WETHERILL PARK

RESOURCE RECOVERY AND RECYCLING FACILITY
Response to Submissions

SSD 7401

Prepared for **Bettergrow Pty Ltd**

PROJECT	PROPOSED GREENSPOT RESOURCE RECOVERY AND RECYCLING FACILITY 24 DAVIS ROAD WETHERILL PARK NSW 2164	PROJECT NO.	1521
CLIENT	BETTERGROW	SCALE	1:500
TITLE	OVERALL SITE PLAN	JOB NO.	0604-16
		SHEET NO./ISSUE	A01 / D

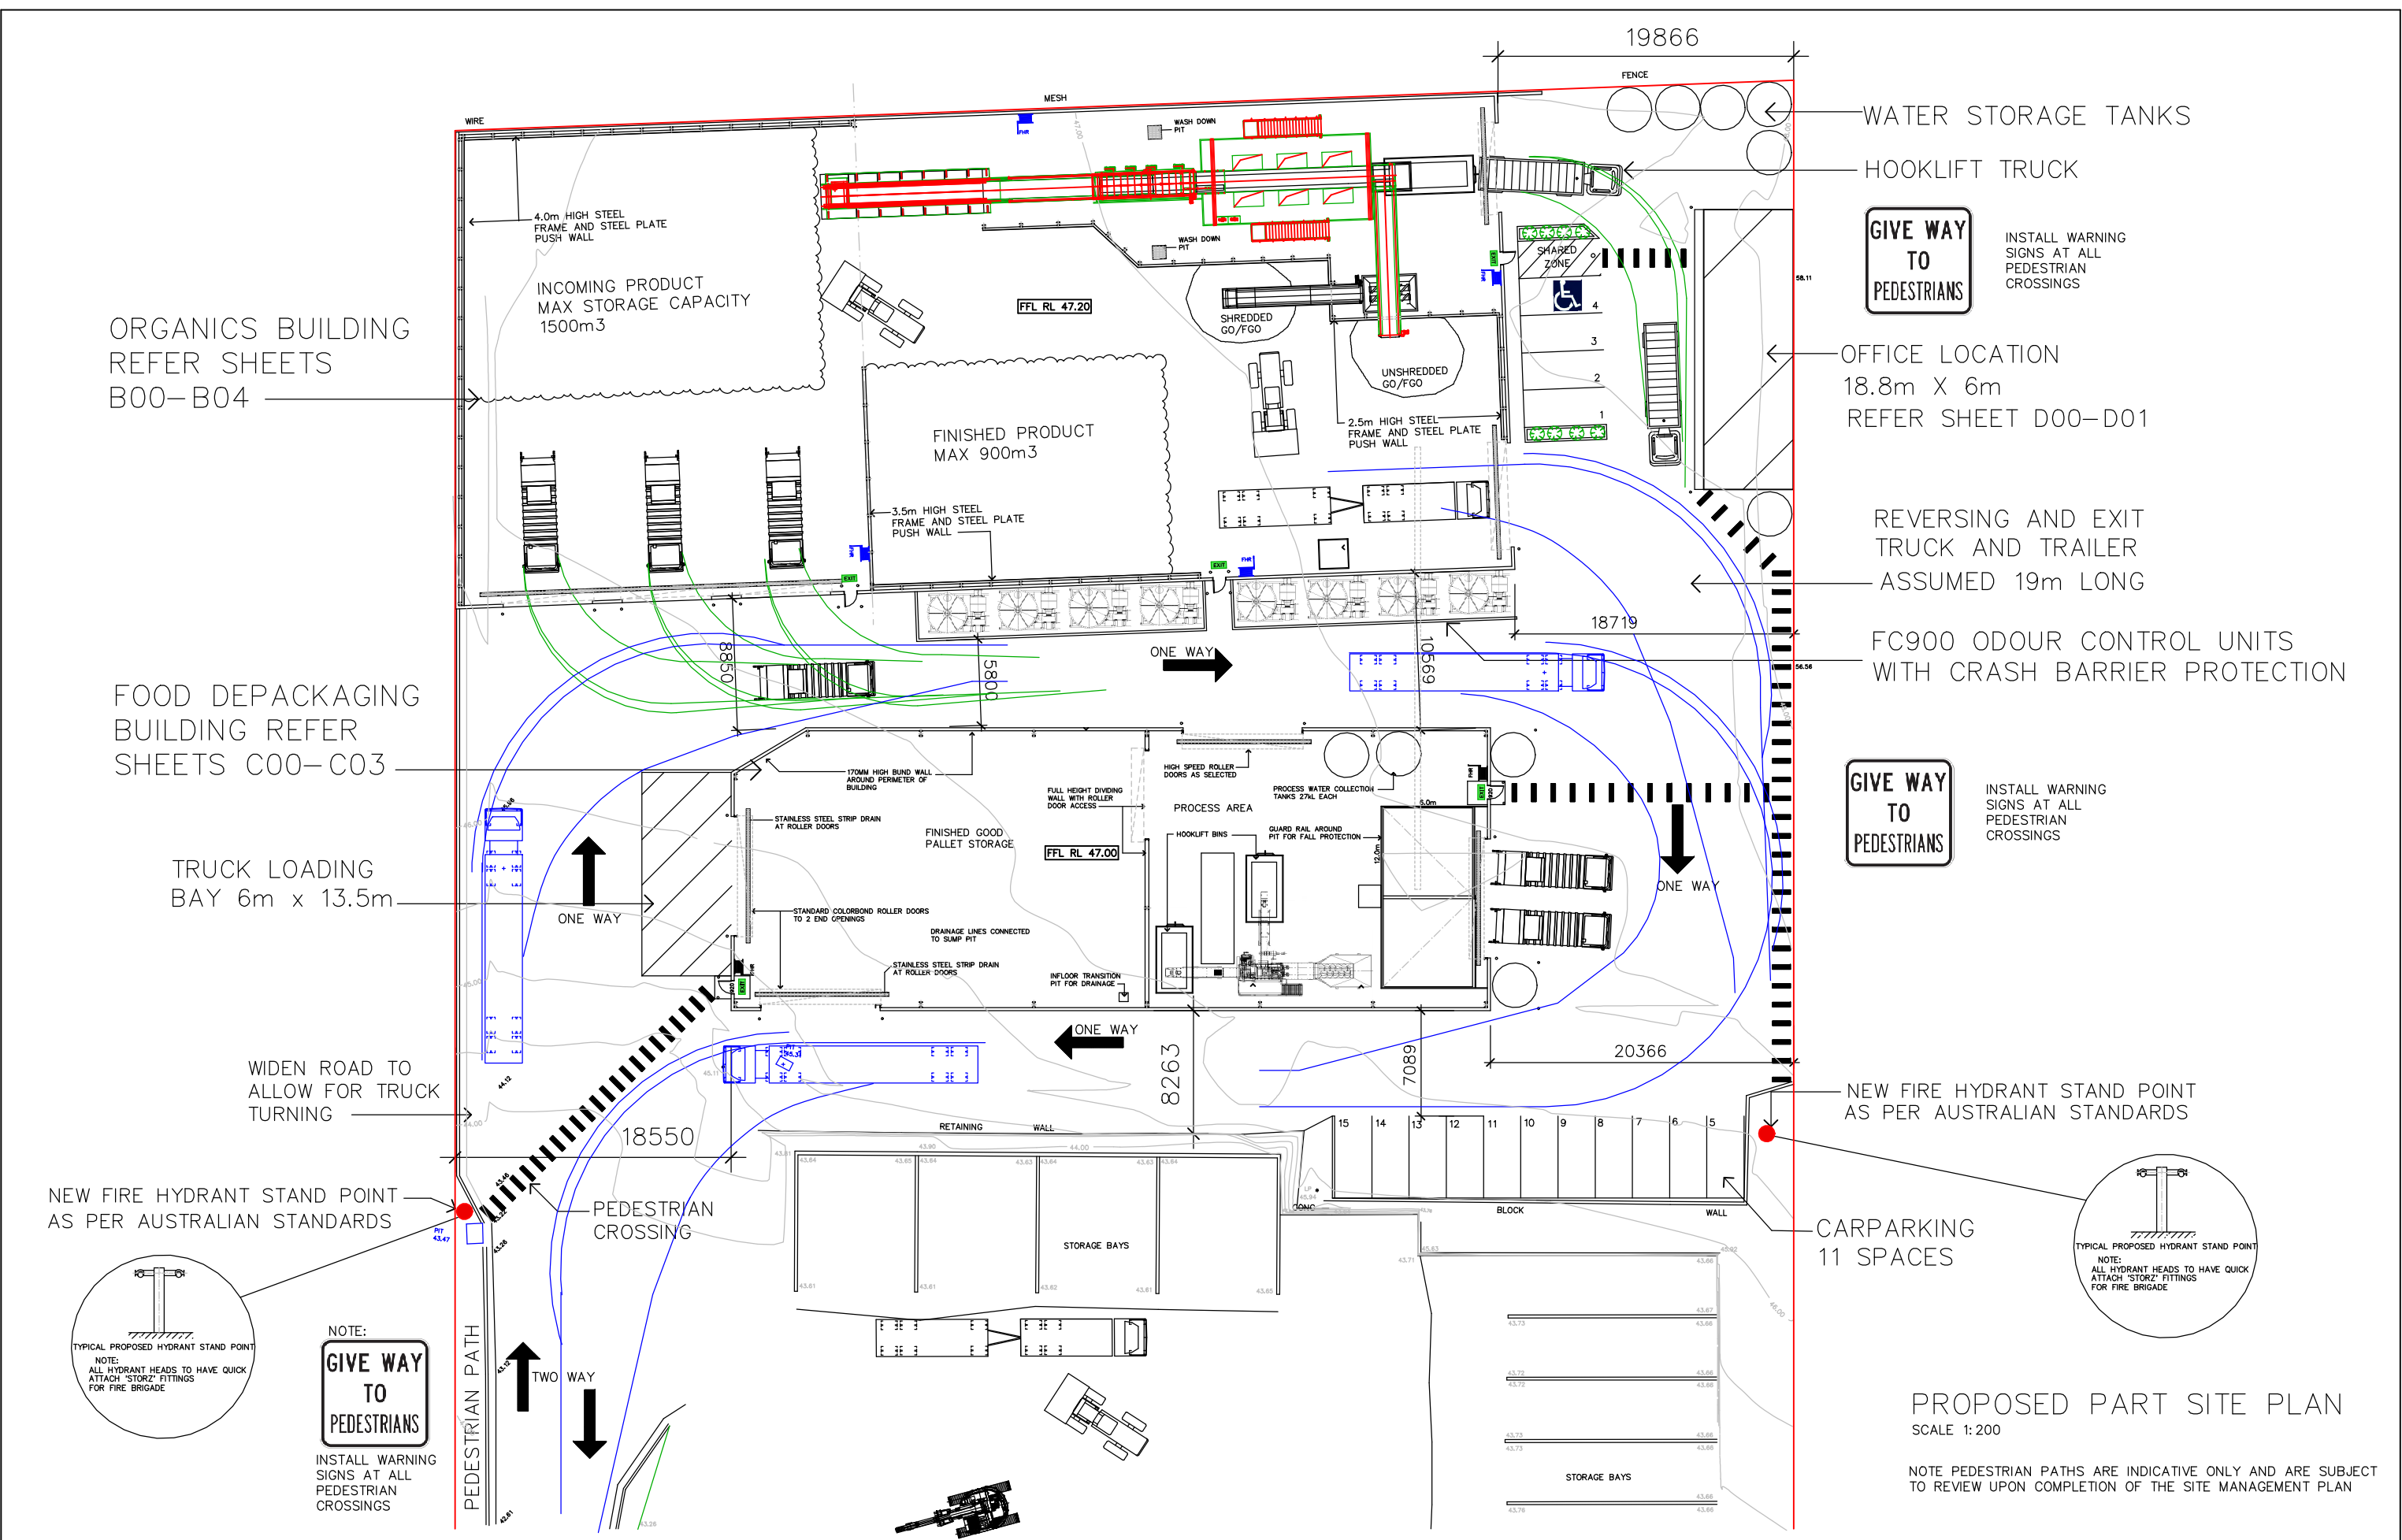
21. The OIA states on Page 15 that potentially odorous air from the food de-packaging building will be ducted to the ORPB building, mixed and treated by the carbon filter unit prior to release into the atmosphere. Please show on a plan where the ducting and stacks will be located including their elevation

Page 15 of the odour assessment (Appendix 8) states that 'potentially odorous air from the Food De-packaging building will be ducted to the Organics Reveal and Processing Building where it will be mixed and treated by the carbon filter unit to release into the atmosphere'. However the figures do not show the ducting or the stacks, are the 8 carbon filters enough to service the two buildings

Revised plans **A01, A02, B01, B02, B03, B04, C02, and C03** are attached within **Appendix 2** to this report. These revised plans show that supported duct work at a height of 5.95 metres will connect the Food De-packaging building and the ORPB (FOGO) building which will allow the treatment of odorous air from the Food De-packaging building through the carbon filters on the FOGO building. The stacks on the 8 odour units will be at a height of 8 metres, which is 2 metres above the height of the FOGO roof line.

Revised plans **A01, A02, B01, B02, B03, B04, C02, and C03** are attached within **Appendix 2** to this report. These revised plans show that supported duct work at a height of 5.95 metres will connect the Food De-packaging building and the ORPB (FOGO) building which will allow the treatment of odorous air from the Food De-packaging building through the carbon filters on the FOGO building. The stacks on the 8 odour units will be at a height of 8 metres, which is 2 metres above the height of the FOGO roof line.

TITLE: FIGURE 8: PROPOSED SITE LAYOUT - PLAN VIEW

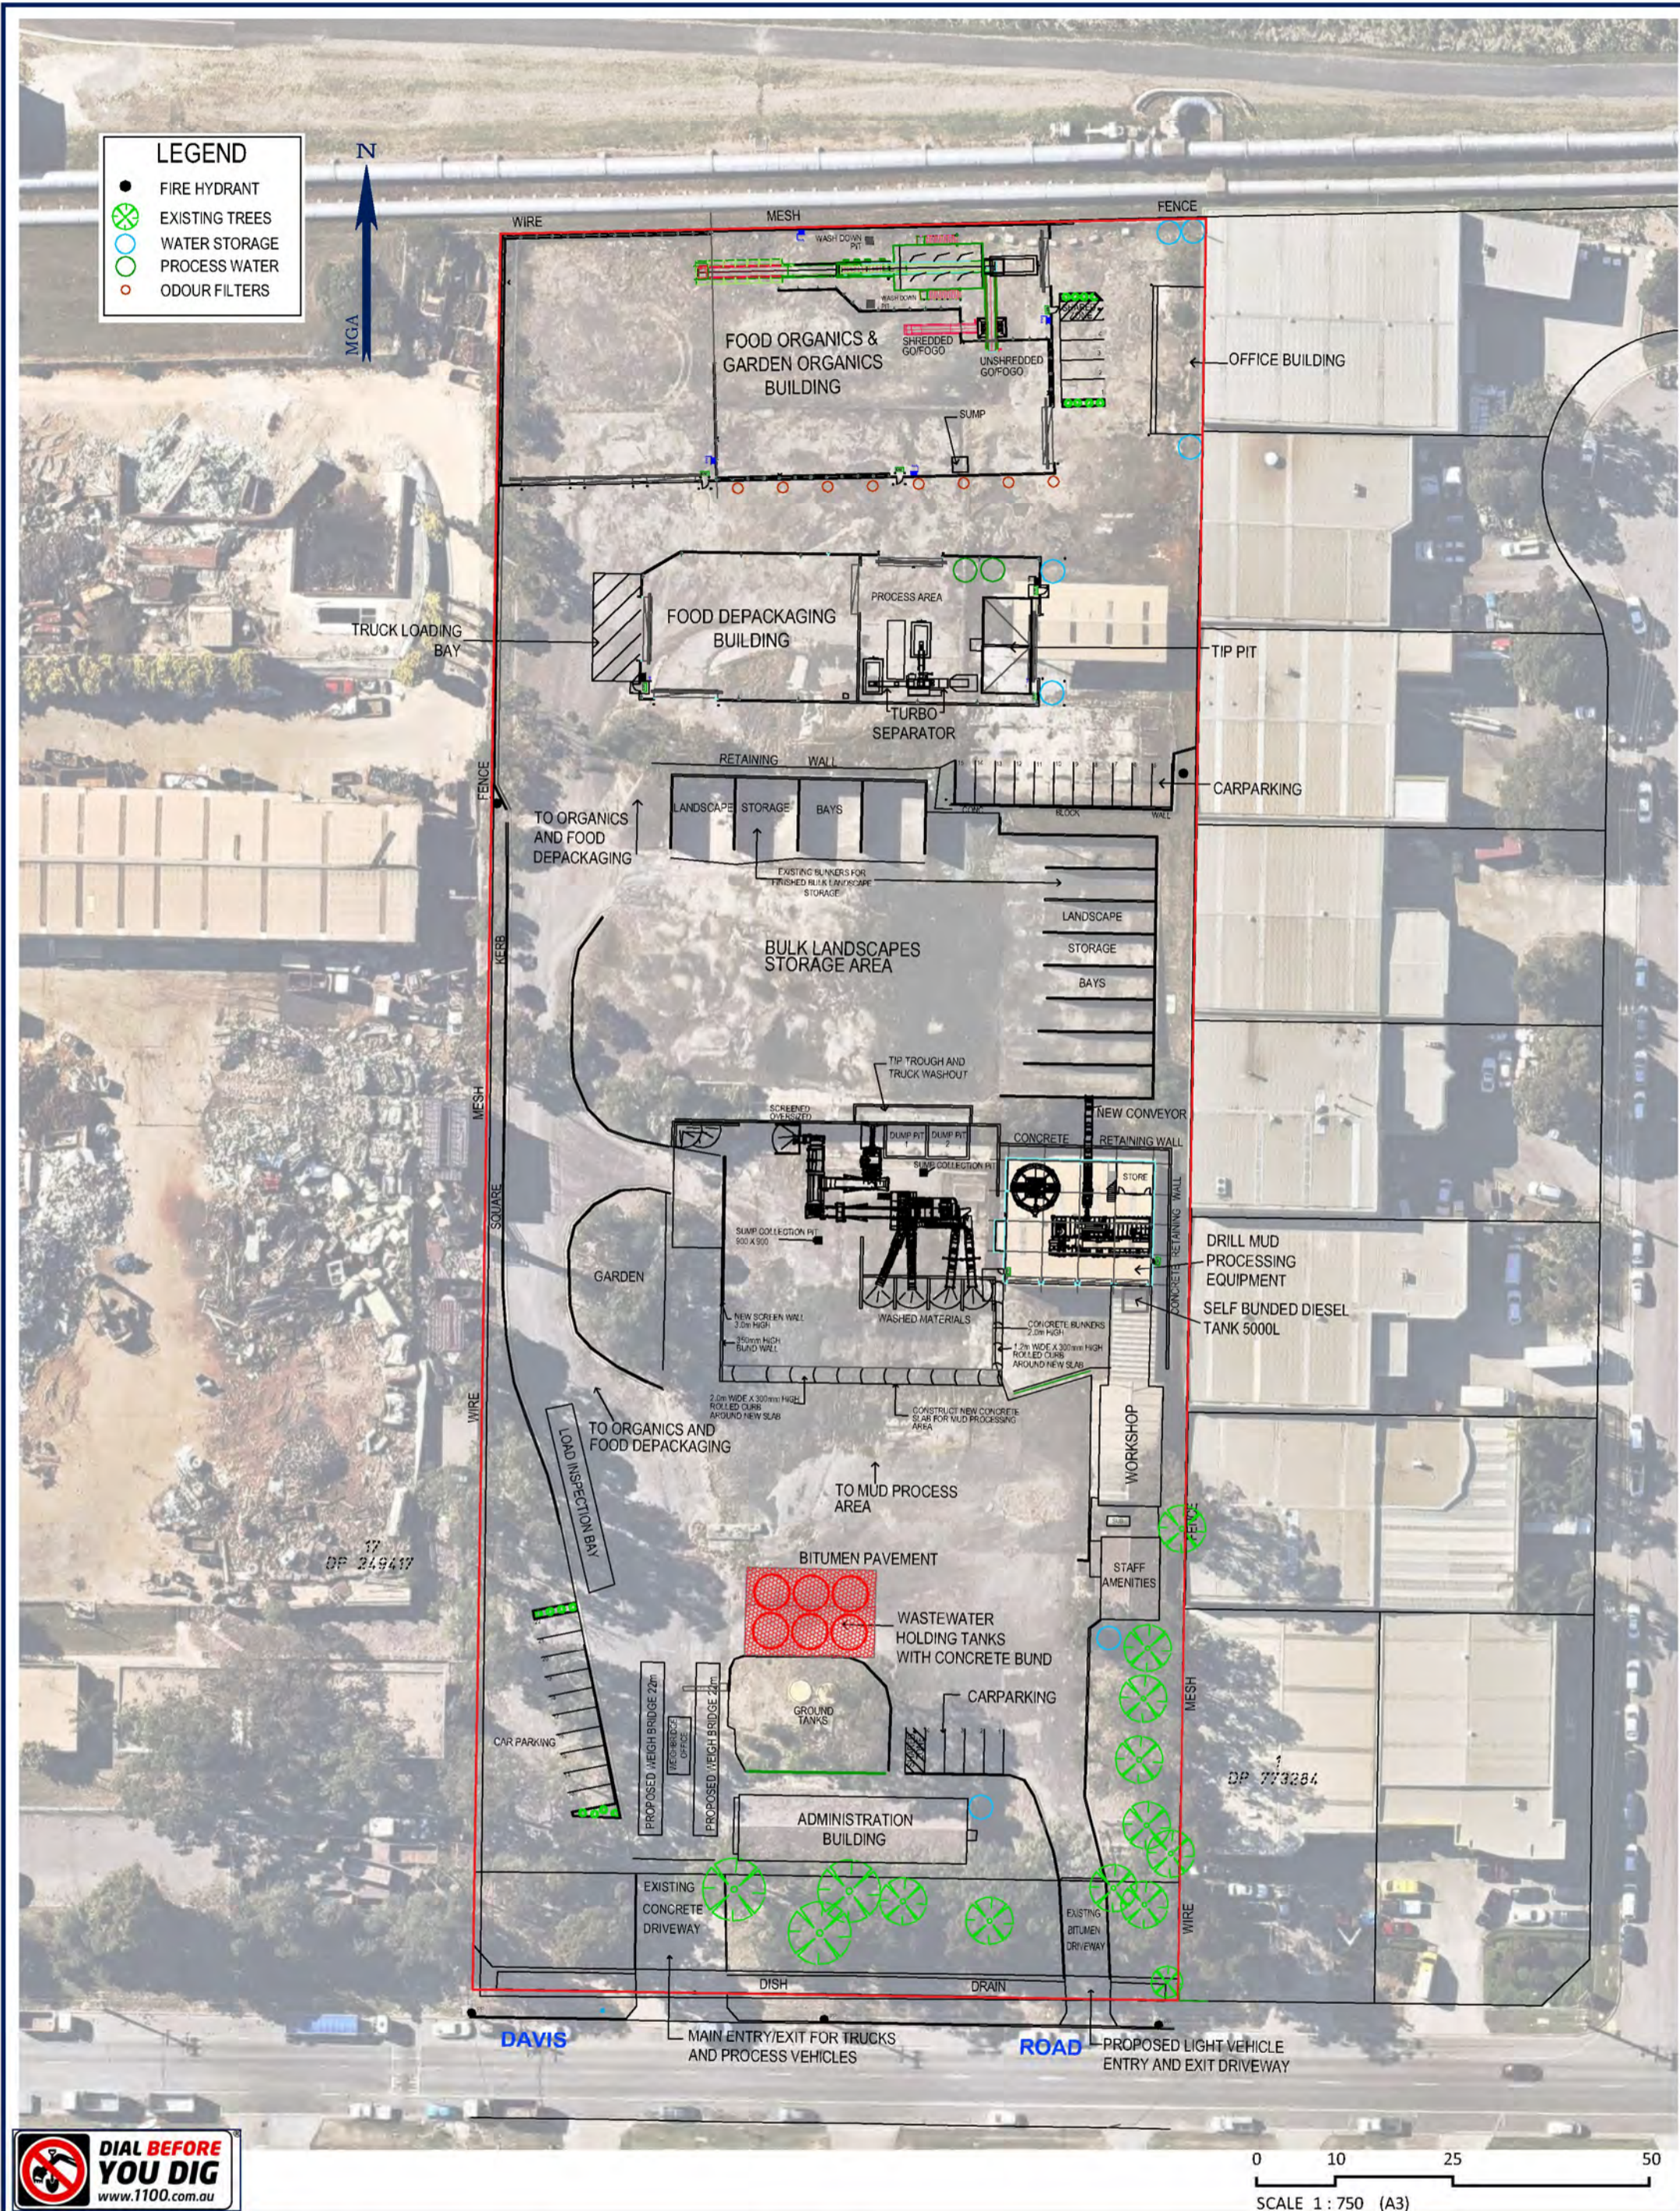
23. Please detail the location of the truck wash it does not appear to be included on Figure 8 of the EIS

The location of the truck wash is on the tipping apron on the mid-level of the site. Drill mud trucks and bulk landscape trucks are washed down on this apron to allow all dirty water to be collected within the dirty water system and processed through the CD Enviro drill mud system. An updated **Figure 8** is attached within **Appendix 2** to this report which has been labelled to show the location of truck washing. Organics trucks are washed down either in the FOGO shed or into the tip pit at the Food De-packaging building. This water is either taken off site for re-use at one of Bettergrow's composting facilities or applied to organic waste to re-introduce moisture. The collection of this water has been accommodated for in the design of the internal leachate management system.

Figure 1: Noise Contours, $L_{Aeq,period}$ dB

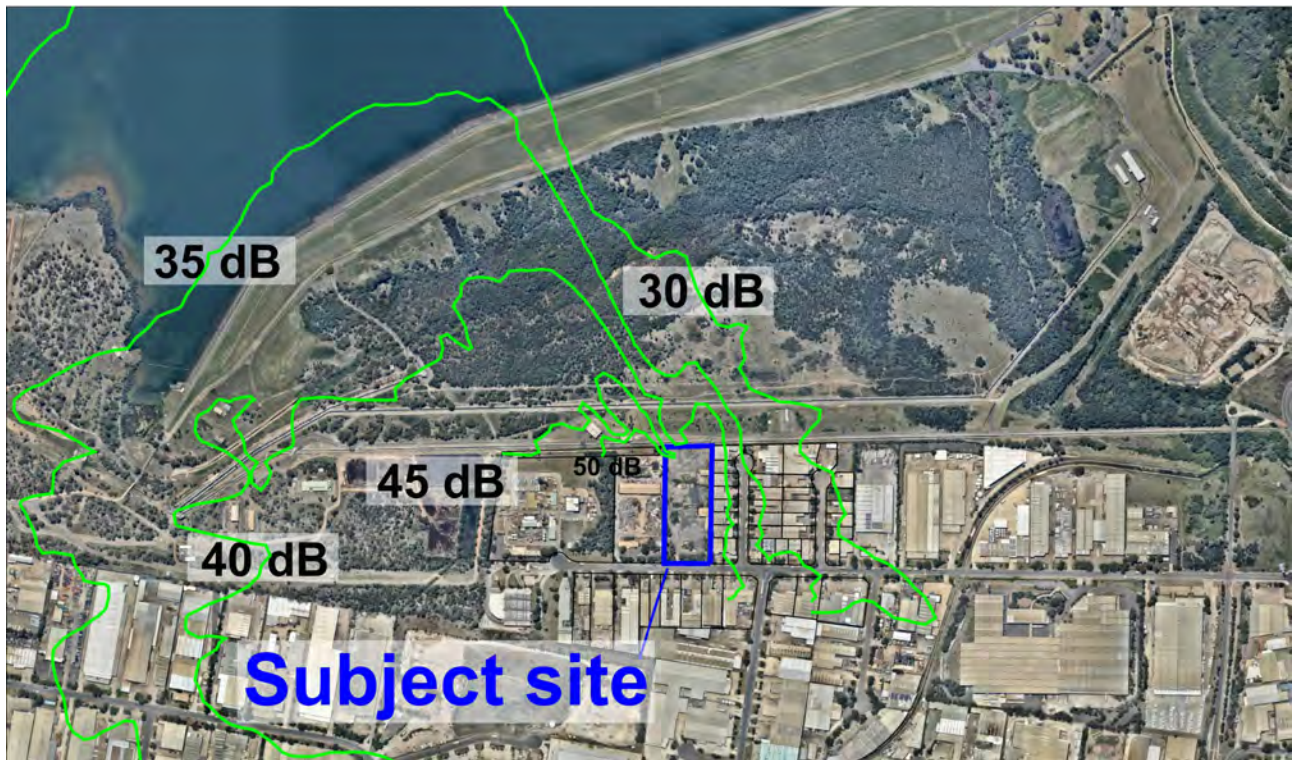
Further to the detail provided above (and in the EIS), additional noise modelling has been undertaken of the area directly to the north of the site within the Western Sydney Parklands area. Noise contours over this area show predictions for the majority of the area are less than $L_{Aeq,period}$ 45 dB. A small area immediately north-west of the subject site exceeds 50 dB, however this area is located between two pipelines and is unlikely to be used for recreation.

The assessment indicates the proposed operation would not impact noise amenity in the Western Parklands Recreation area (refer **Appendix 3** to this report). A revised noise contour plan, covering the Western Sydney Parklands area, is shown as Figure 1 in the **Noise and Vibration Addendum Report** attached as **Appendix 3** to this document.

The noise contours show predictions for the majority of the vacant land area are less than $L_{Aeq,period}$ 45 dB. A small area immediately north-west of the subject site exceeds 50 dB; however this area is located between two pipelines and is unlikely to be used for recreation.
